Date 24 January 2024
Our Ref DS/FS24/0007
Your Ref PT_GD/23/01423/FULEIA
Subject 1 Undershaft London EC3A 8EE

LPA Reference	23/01423/FULEIA
Proposal	Demolition of the existing buildings, retention
	and partial expansion of existing basement
	plus construction of a ground, plus 73 storey
	building (plus plant) for office use (Use Class
	E(g)); Retail/food and beverage (Use Class
	E(a)-(b)); Public amenity space (Flexible Class
	E(a)-(d) / Class F1 / Sui Generis); publicly
	accessible education space and viewing
	gallery at levels 72 and 73 (Sui Generis); public
	cycle hub (Sui Generis); plus podium garden
	at level 11, public realm improvement works,
	ancillary basement cycle parking, servicing,
	plant, highway works and other works
	associated with the proposed development.
Location	1 Undershaft London EC3A 8EE
Borough	City of London
Case Officer	Gemma Delves

Planning report GLA/2024/0051/S1/01 4 March 2024

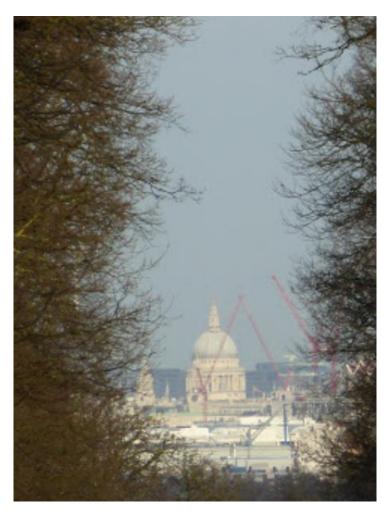
The Council notes the previous permission in November 2019. The revised scheme would be approx. one storey higher than the 73 storey building approved at the application site under LPA reference: 16/00075/FULEIA by the Corporation on 8 November 2019.

It is clear that the proposed scheme will not be readily visible from the Mound as it would be obscured by vegetation. Whilst the proposed building is not shown to be readily visible within the Protected Vista as it would be screened by vegetation, the view post tree pruning / seasonally is likely to be more obvious. It is important that the limitations/restrictions imposed by both the Secretary of State and the Mayor of London are strictly adhered to and the impacts from Kings Henry's Mound to St Pauls Cathedral are fully considered in the final assessment and as part of a planning balance. The Corporation should take adequate steps to determine how the proposed development would when completed impact on the background of the view from King Henry VIIIs Mound to St Pauls Cathedral and take all necessary steps and precautions to ensure that this is in accordance with the limitations imposed.
